Technical information

TI No.: 43.05U18009A

Model: TC 400

TITLE: **Incorrect version of the pressure limiting valves at the driven axle**

M43.05-0016-74

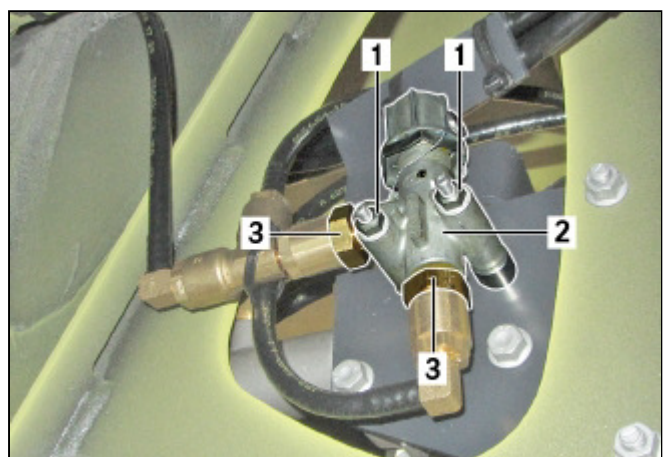
Pressure limiting valves with 80 psi nominal pressure fitted.

Mix-up of components in the production process.

Fit 60 psi pressure limiting valves.

1. Unscrew screw-in fittings **(3)** for the compressed-air connections from pressure limiting valve **(2)**.

2. Remove screws **(1)** and remove pressure limiting valve **(2)**.
3. Secure new pressure limiting valve **(2)** using screws **(1)**.

4. Screw screw-in fittings **(3)** for the compressed-air connections with new O-rings into pressure limiting valve **(2)** and tighten.
